CENTURY OAKS
ABG DEVELOPMENT
M.D.P./P.U.D. PLAN

Re: Century Oaks (Amending) MDP/POADP # 460-B

The City Staff Development Review Committee has reviewed Century Oaks (Amending) Master Development Plan M.D.P. (formerly POADP) Preliminary Overall Area Development Plan # 460-B. Please find enclosed a signed copy for your files. Your plan was accepted however please note the following:

The City Staff Development Review Committee has reviewed Century Oaks (Amendment) Preliminary Overall Area Development Plan/ Planned Unit Development (PUD). Please note that your plan was not accepted, based on the following:

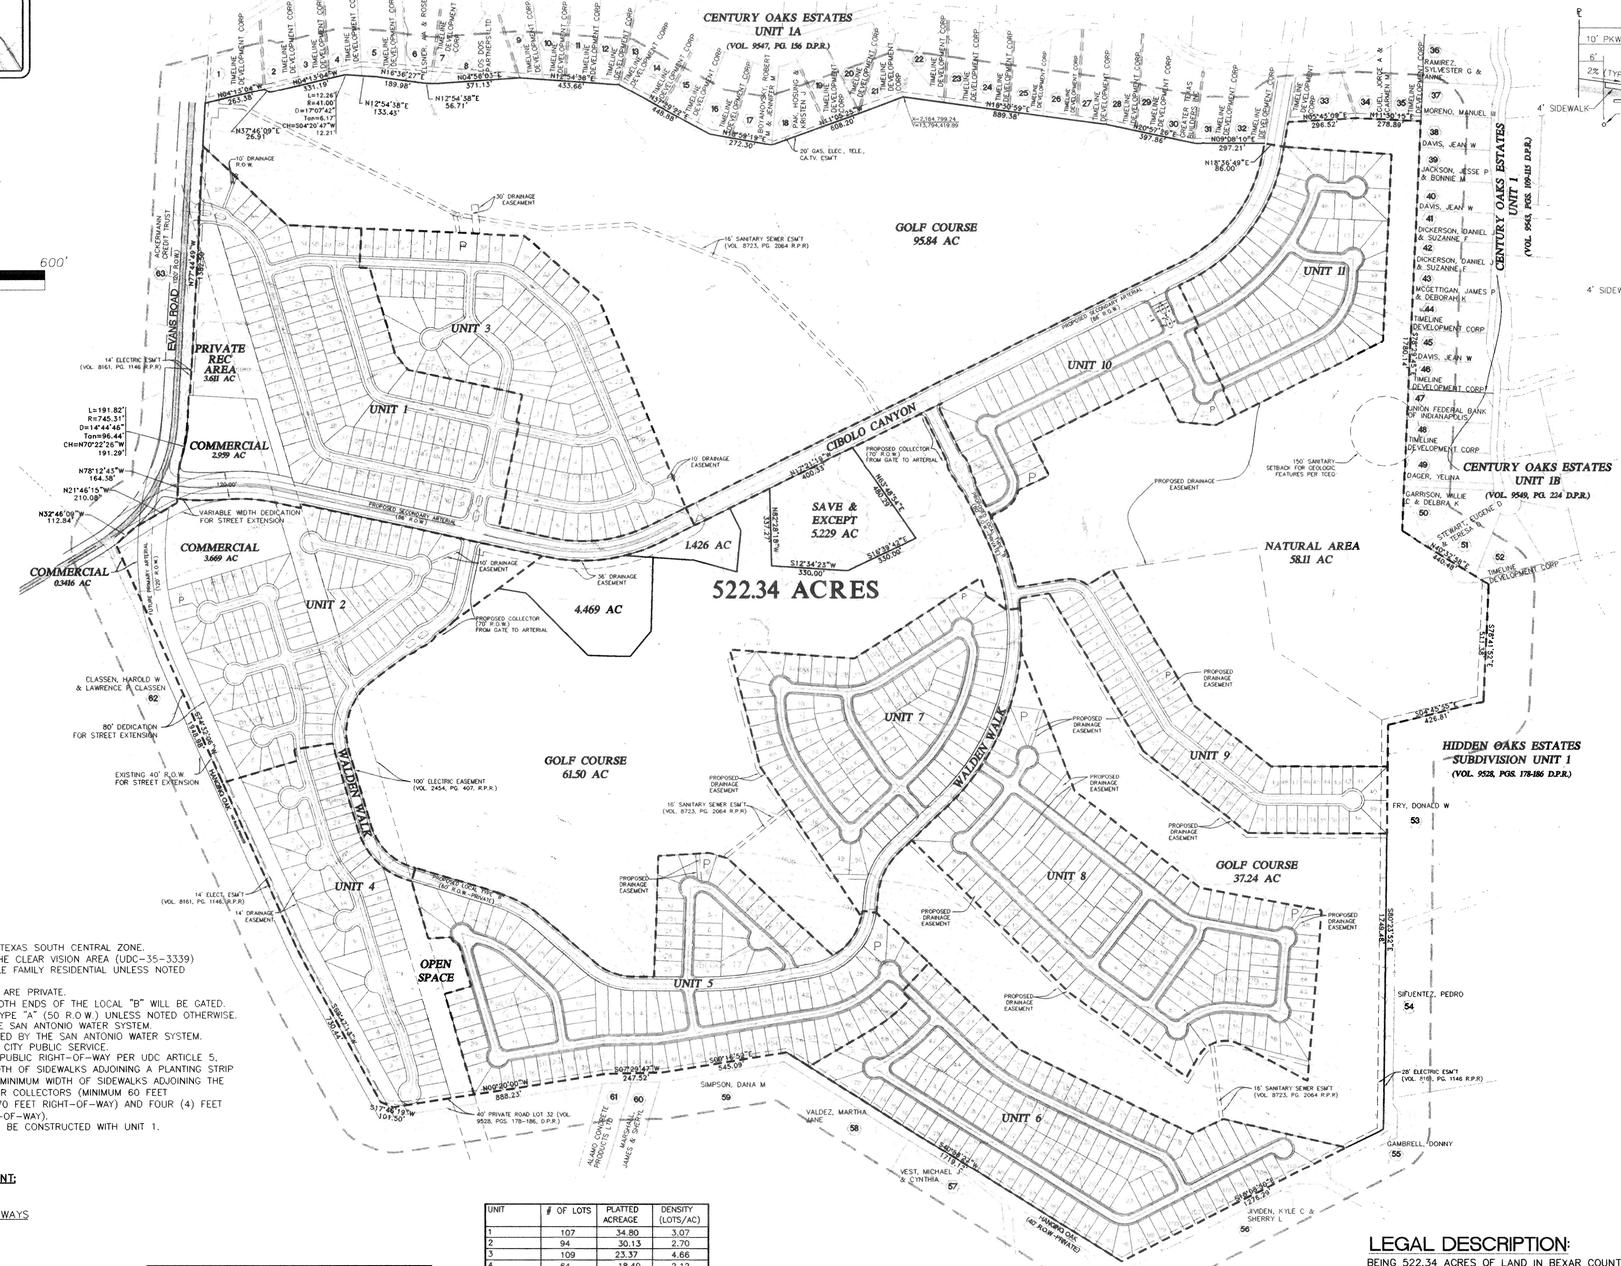
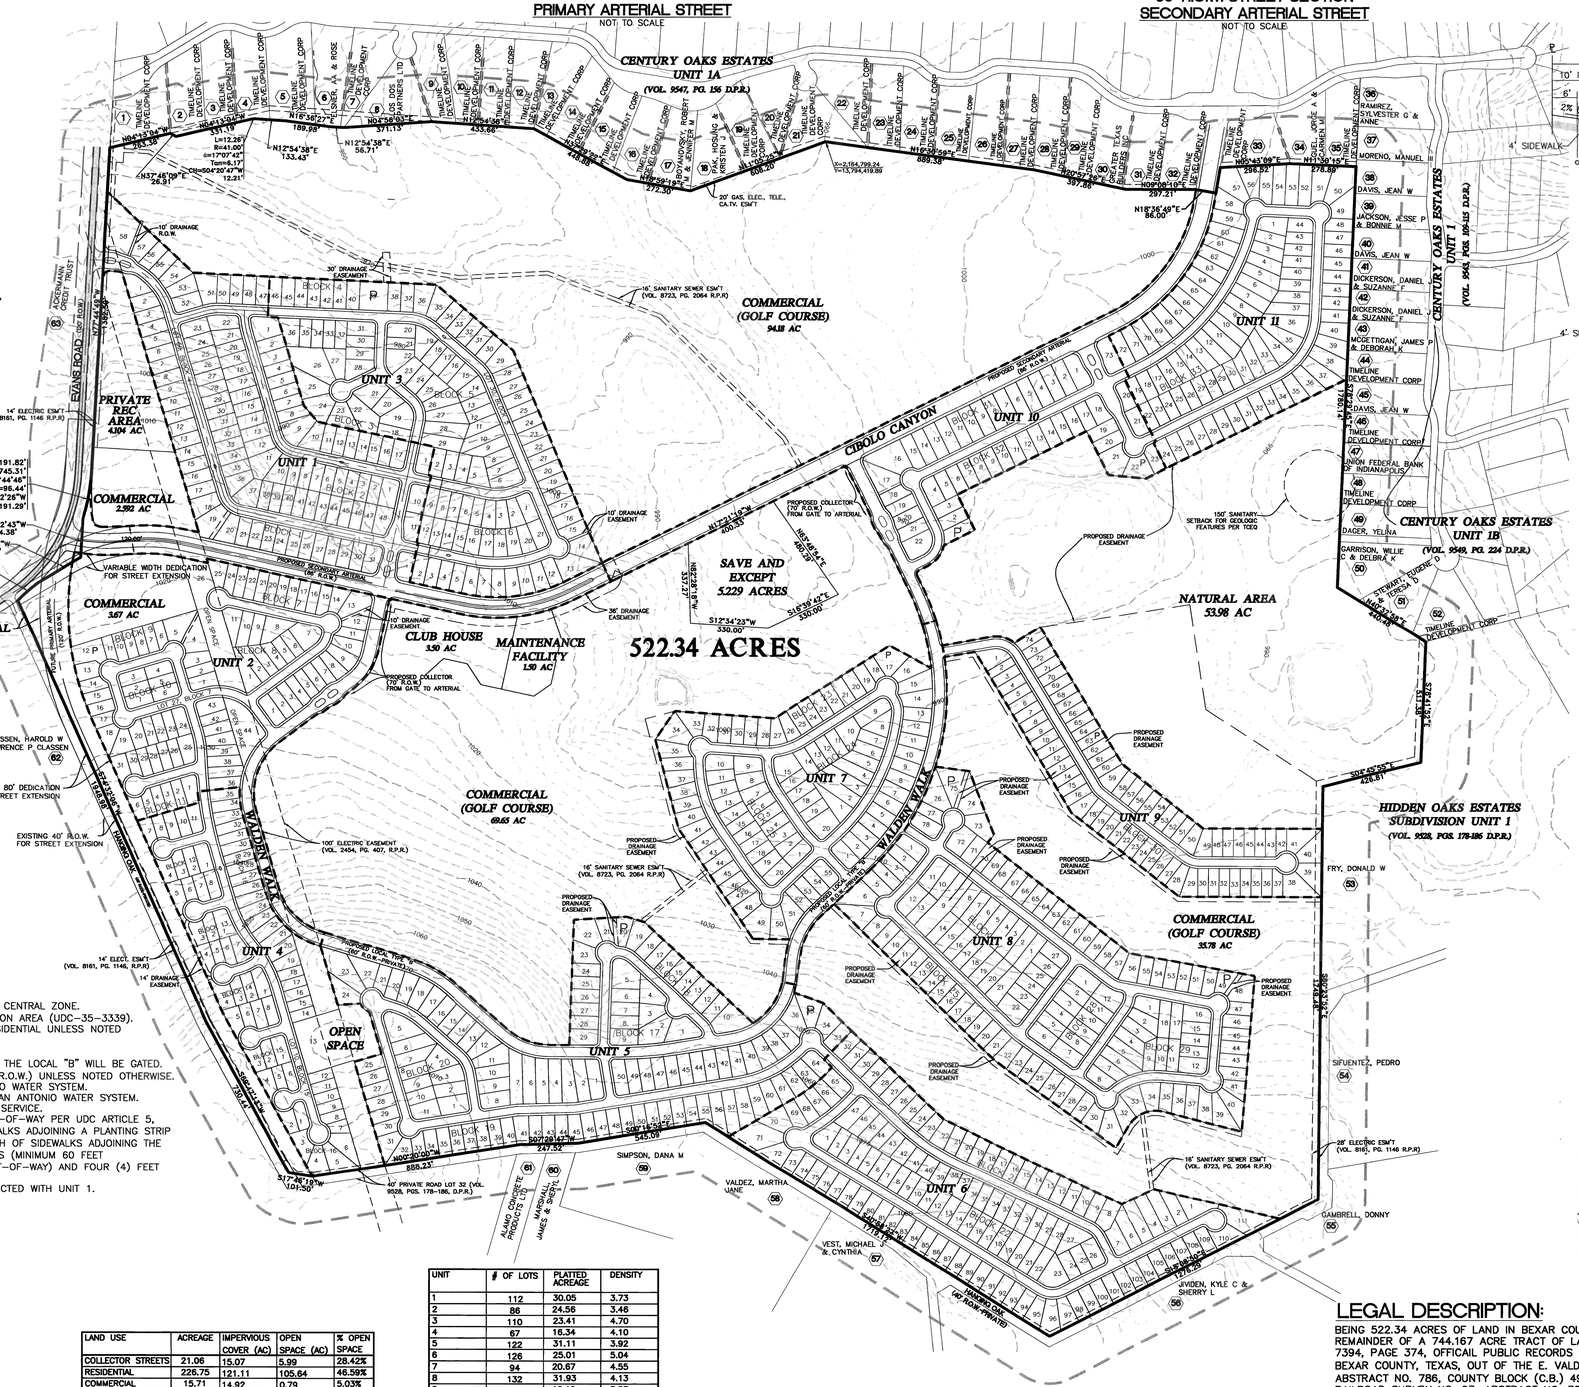
- In consideration of public safety and convenience, excessive grades by reason of topography should be avoided in street layouts and arrangements.

- Cibolo Canyon - Dedicate 86-feet of ROW and construct a 4-lane divided roadway (Secondary Arterial Type B). The limits of construction shall be extended from Evans Road to Angosturo Boulevard as shown on the City of San Antonio Major Thoroughfare Plan (MTP).

- Evans Road (east of proposed Cibolo Canyon) – Dedicate in width, 120-feet of proposed Cibolo Canyon adjacent to this proposed project. This will require a property dedication by the developer.

- The developer shall be responsible for upgrading the intersection of Evans Road and Cibolo Canyon as shown on the approved Master Development Plan. This includes sufficient left-turn storage, right-turn deceleration lanes, upgrading lane capacity on Evans Road and a traffic signal when warranted.

- Construction of an internal collector street system. Collector streets with 70-feet of ROW and 44-feet of pavement shall have no houses fronting.

- All proposed median openings on Cibolo Canyon should provide sufficient left – turn storage for northbound and southbound traffic. For tee – intersections on Cibolo Canyon the median shall provide a bullet nose design as described on page 701 of 2001 AASHTO Policy on Geometric Design of Highways and Streets (AASHTO Green book).

- Right turn deceleration lanes shall be constructed on Cibolo Canyon and Evans Road for all collector streets accessing these arterial streets. This construction may require dedication of additional right-of-way.

- **Option # 1, Exhibit- "A"**
- As per (UDC) section 35-4109

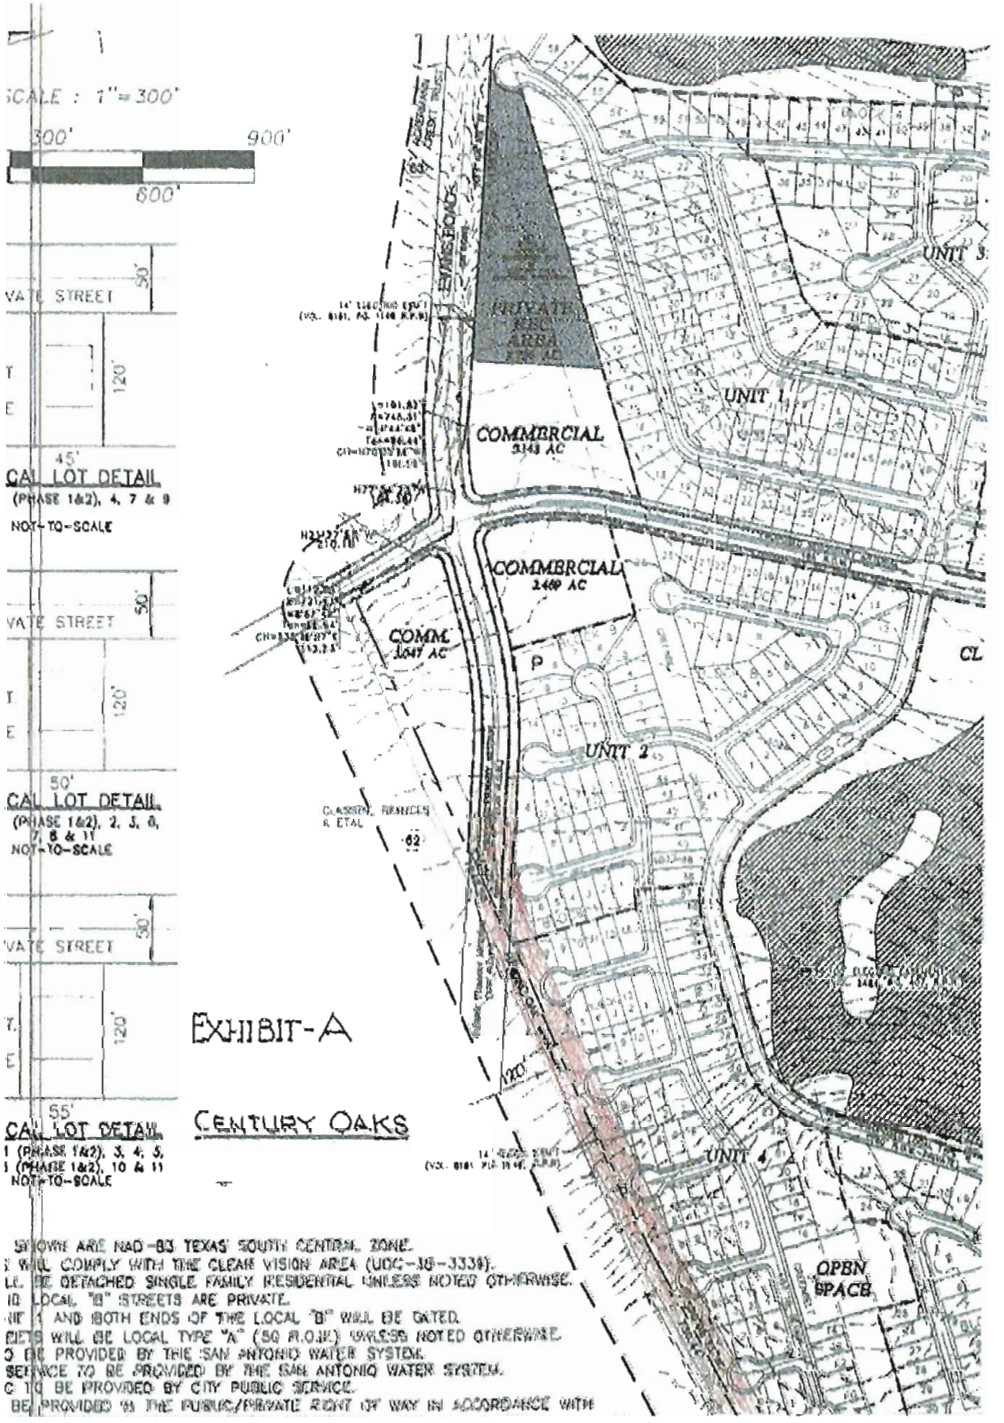
1) The plan does not comply with (old UDC) Section 35-4109 Arterial streets
"Where a Primary or Secondary Arterial street, as shown on the Major Thoroughfare Plan, traverses or is contiguous with an area being platted, such Primary or Secondary Arterial Street shall be platted in the location and of the width indicated by the requirements of the Major thoroughfare plan and these regulations."

2) Section 35-4113 (old UDC), Pavement and right-of-way width.
Evens Road is on the Major Thoroughfare Plan and calls for a Primary Arterial Type "A"; your proposal fails to identify this Primary Arterial as proposed on the Major Thoroughfare Plan for the City of San Antonio.
